Application Note 60

The Peregrine PE4312 is the updated digital step attenuator (DSA) designed as a direct replacement for the PE4302 series DSA. Although primarily designed as a PE4302 replacement, it can also be used to replace the PE4305 and PE4306 devices.

Figure 1 • PE4302 Application Circuit

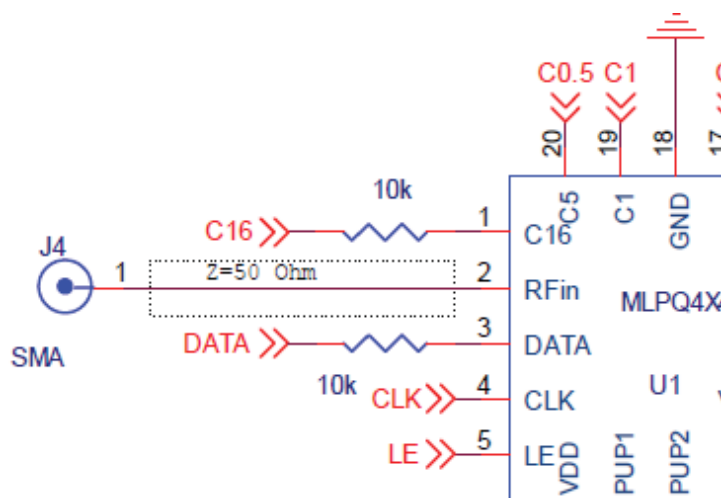
The PE4302 application circuit contained two resistors in the C16 and DATA lines.

These resistors were originally placed to remove a resonance between the RF_{IN} pin and the connection to the adjacent pins. This resonance caused degradation in the PE4302 DSA performance above 2.5 GHz. The PE4312 does not need resistors on the C16 or the DATA line and it is preferable to remove them or reduce the values so the logic threshold levels are met.

Users should ensure that the PE4312 logic levels are compatible with the data levels in the design. If the series 10k resistor is left in the circuit on the DATA line or if the clock period is too short, the data V_{IL} threshold may not be met in the high to low transition.

The PE4312 can successfully be used to replace the PE4302 in an existing design with appropriate consideration for the logic levels and removal or reduction in value of the DATA line resistors. The PE4312 can also be used in new designs based upon an older PE4302 design provided the maximum digital input voltage remains 3.3V.
